Proposed Draft

Appendix B

Discussion Draft – Public Comments and Meetings

This document is a compilation of public comments on the Better Housing by Design Discussion Draft, received during the public comment period from January 22 through March 19, 2018. The comments are organized as follows:

Inner Eastside map showing Multifamily in tan and Mixed Use in brown.

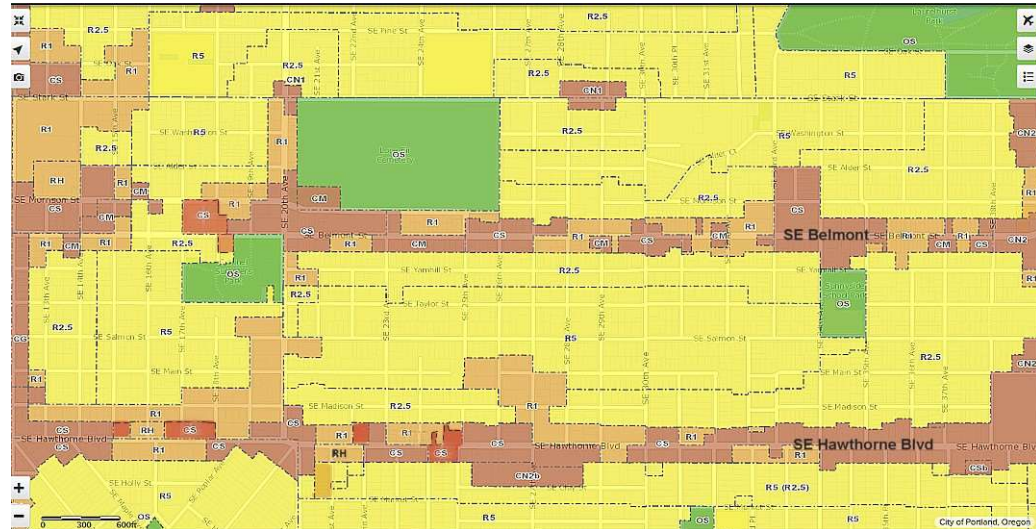
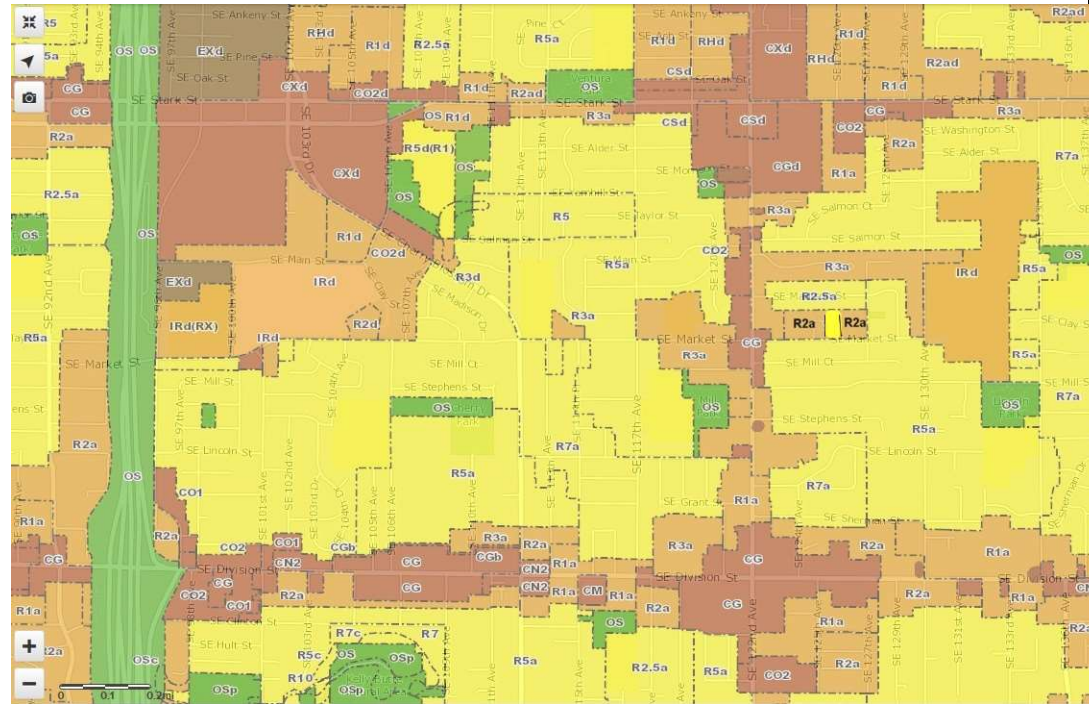
<p>Requiring this use within 100 feet of a civic corridor is unnecessarily strict. Further, I would feel significantly better about putting a child in daycare if I knew that the facility was 200 -- 300 feet away from a busy street. In typical inner neighborhoods, this would allow a daycare an entire block away from a corridor. This is a safety advantage *and* it allows daycare uses to avoid competition with other commercial uses in some circumstances.</p> <p>Accessory commercial use:</p> <p>It may be that I don't understand this language, but a leasing office or building mail room (that may provide shipping services like an Amazon locker, which could be considered a commercial use) ought to be allowed external signage and possibly external entry in a sufficiently large building.</p>
<p>3/19/2018</p>	<p>to: Bill Cunningham, BHD Staff cc: Planning & Sustainability Commission</p> <p>Attached are two documents:</p> <ol style="list-style-type: none"> 1. My comments on the Better Housing Discussion Draft 2. My suggestions of modified zone changes (R2 to RM2) that could be made as part of the Better Housing project. <p>Thank you.</p> <p><u>Comments on Better Housing by Design January 2018 Discussion Draft:</u></p> <p>I support many of the concepts in the Better Housing by Design proposal, especially the choice to regulate the RM1 and RM2 zones by FAR, rather than the current “unit density” regulations. The current densities were thought appropriate in 1959. Now, 60 years later, we cannot as a region or a planet, afford to have such low-density housing along major transit corridors, within walking and biking distance of jobs, services and other daily needs. It is critical to set the FARs high enough to result in a significant increase in unit numbers to accomplish the Comp. Plan goals for affordability in every neighborhood and to have compact development that reduces Vehicle Miles Traveled and transportation emissions, to meet our Climate Action Goals. I would say that these goals should over-ride concerns about “giving windfalls to property owners” or other secondary unwritten policy considerations.</p> <p>The Problems</p> <p>Recent development of apartment units in Portland has been concentrated in the Mixed Use Zones, because those zones are <u>not</u> regulated by unit density. This has led to robust residential construction along those few streets in the city that have commercial zoning. Because 47% of Portlanders rent, about one third of the households are a single person, and another third are two persons. The market has responded with studio and one-</p>

bedroom units in buildings along these corridors, where up to 50 units have been built in a 45' height limit on a 100 x 100' lot. These lots can yield an FAR of about 3.25:1, and under the new CM-2 zoning, the bonus for Inclusionary Zoning (IZ) will allow a 4:1 FAR and could result in around 60 units on such sites.

improvement, but the proposed FARs of 1.5:1 base, and 2.25:1 including an IZ bonus severely limit entitlement. With required 5' side and 10' front setbacks and a maximum lot coverage of 60% instead of 85%, it is doubtful that more than around 25 units could be built. The proximity of that figure to the "IZ trigger" of 20 units, makes it seem likely that a number of 19-unit buildings will result, if any. This is a woeful waste of the valuable lots in transit-centric areas.
